JOB TITLE
Extensions and Alterations to
Silverdale Centre
Silverdale Road
Berks RG6 7HS

DRG. TITLE
General Arrangement Drawing

| JOB No. | DRG. No. | REV. |
|---|---|---|
| TBC | BR01 | J |

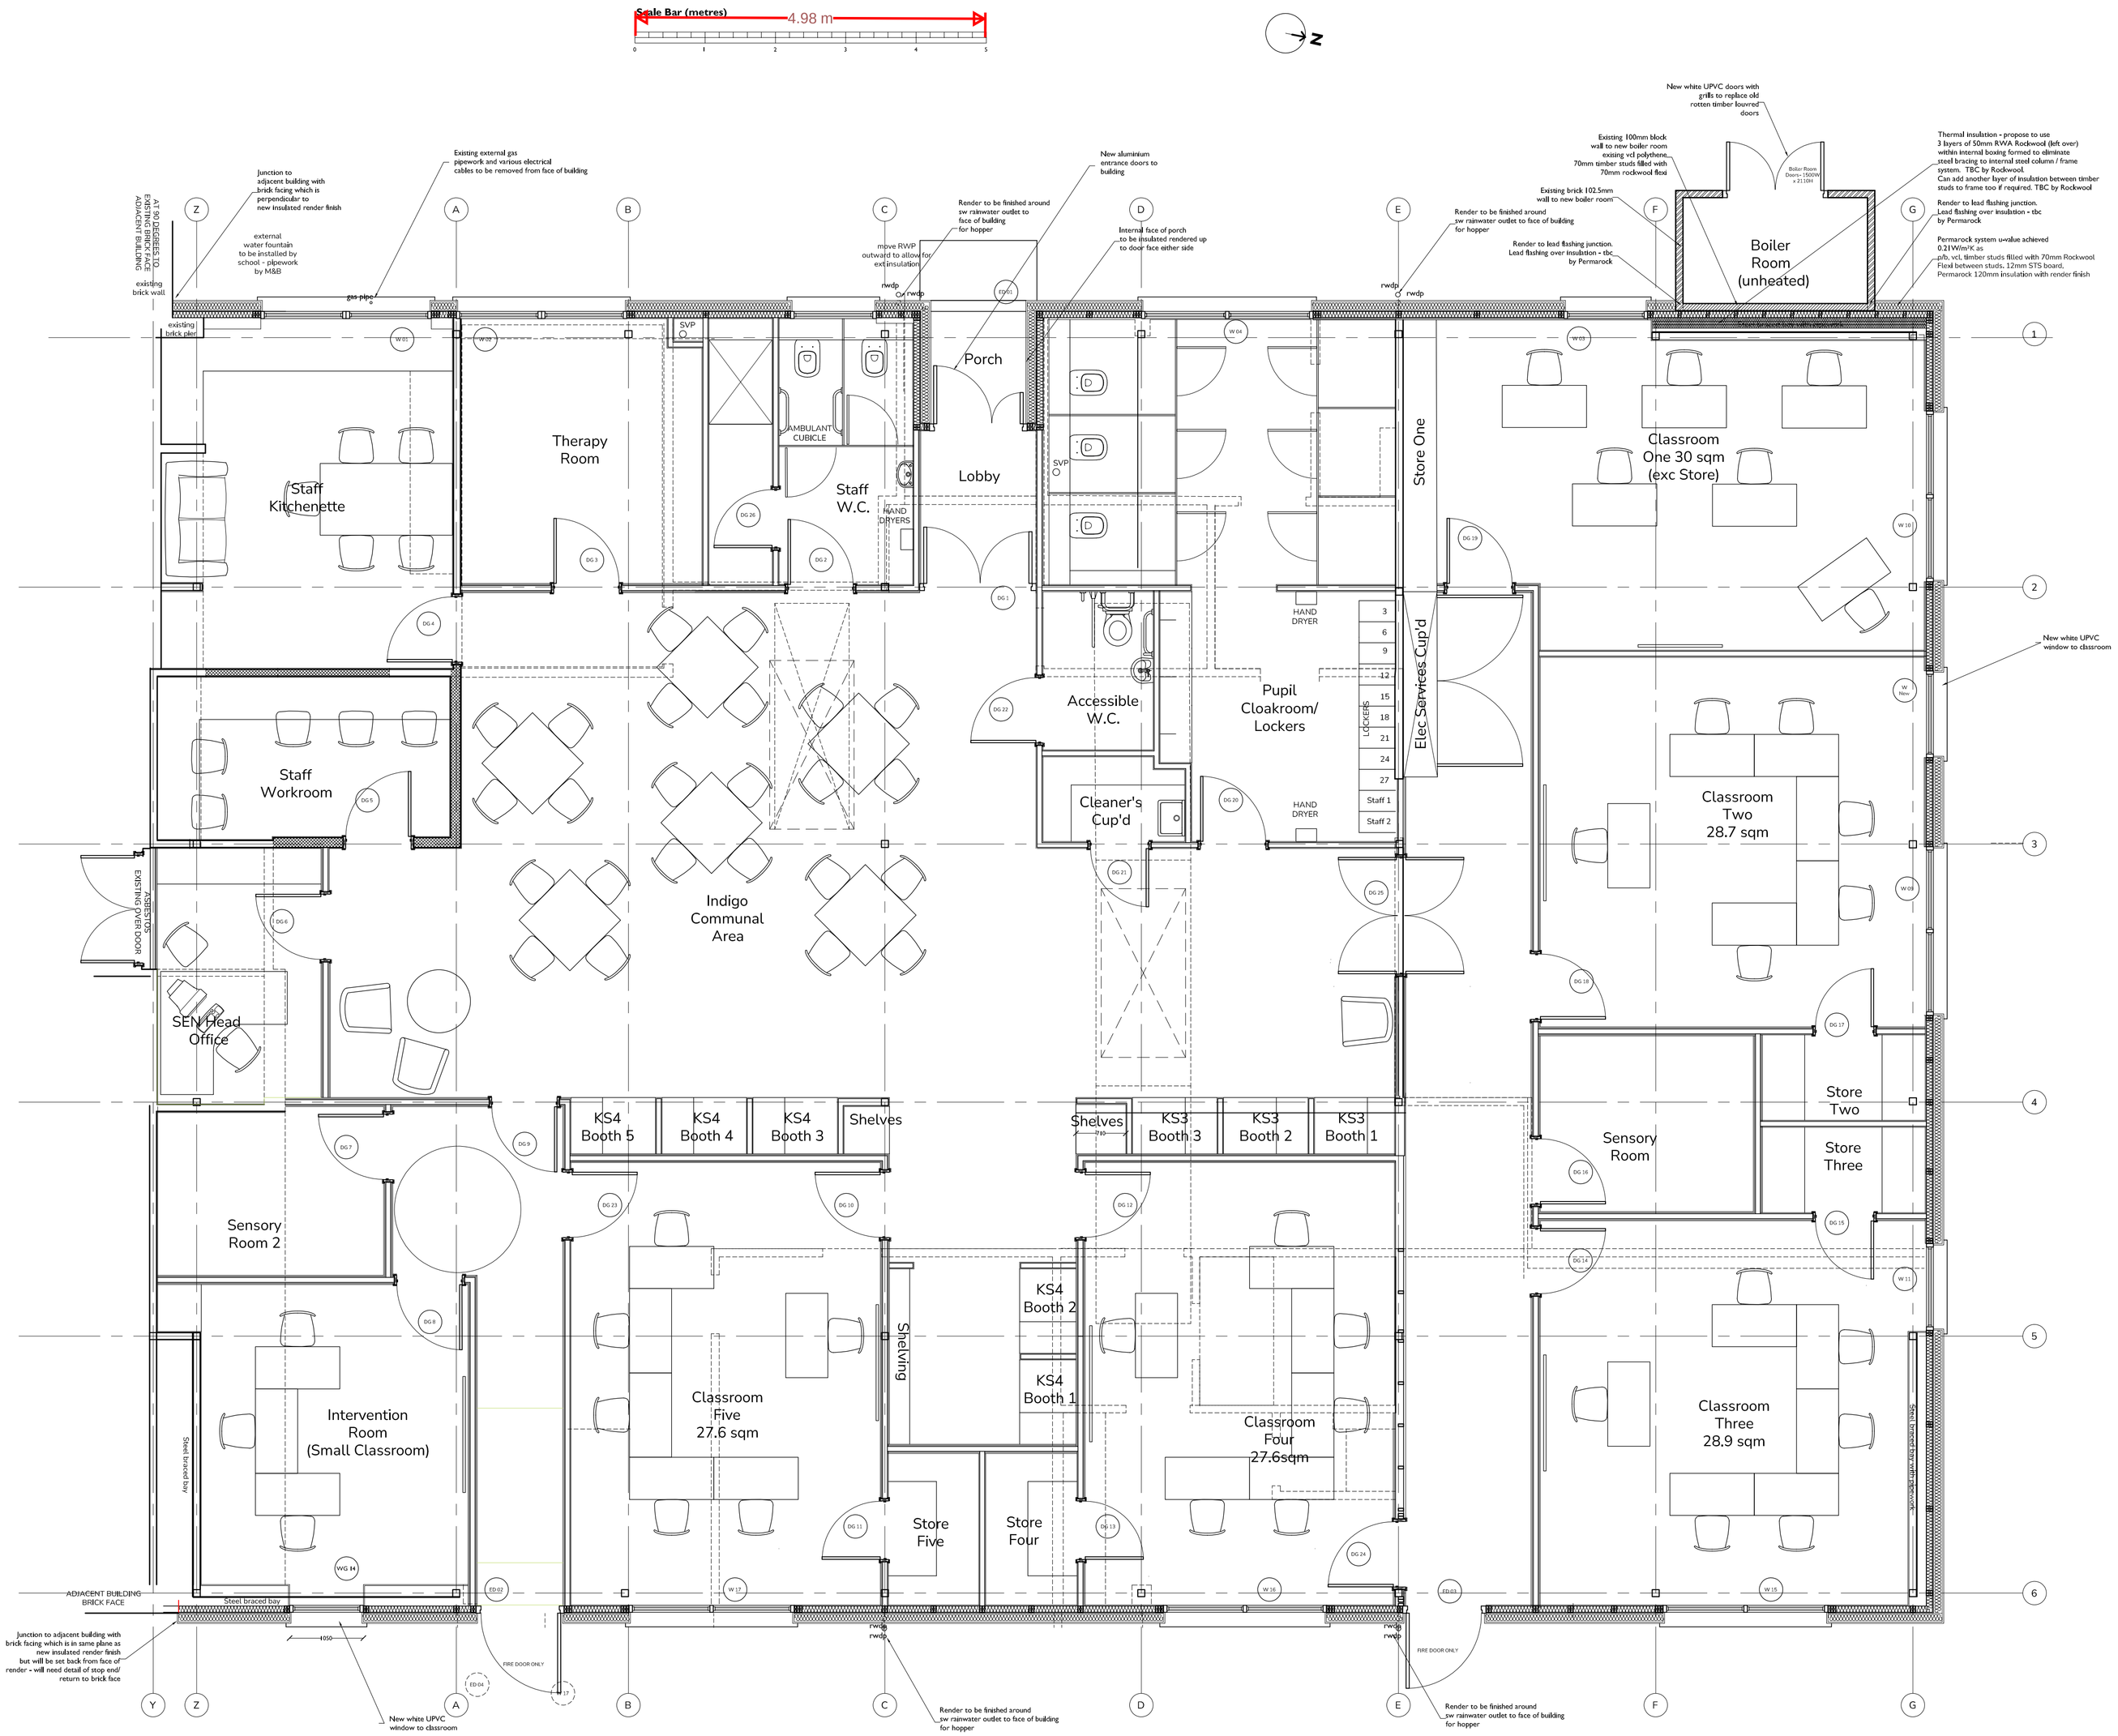
| 16.05.23 | Amended walls to indicate triple studs where large openings. Amended location of shelving to corridor flipped with KS3 booths as agreed with clients. Amended front doors from double doors to door and half as agreed with client to enable insulation externally to porch area. Indicated SVP locations as measured on site 16.05.23 |
| 23.05.23 | Amended to add notation to drawings. Amended Staff W.C. to include shower area, single and half door to main entrance doors and amended internal door location to Classroom One to sit between existing cupboards. |
| 25.05.23 | Amended to indicate door locations for and widths for openings formed in metal stud |
| 26.05.23 | Amended dimensions to door openings from wall corners as discussed with Richard from 75mm to 100m m and as already agreed on with the DRD. |
| 13.06.23 | Amended door/lobby to make wider to suit door openings from IPC for min width to single leaf as part M. |
| 28.06.23 | Amended notation re IPS/cubicle areas for ease of understanding |
| 03.07.23 | Preliminary ceiling grid added |
| 03.07.23 | Put reflected ceiling grid on a separate layout |
| 01.08.23 | Added notation to new doors and windows around building |
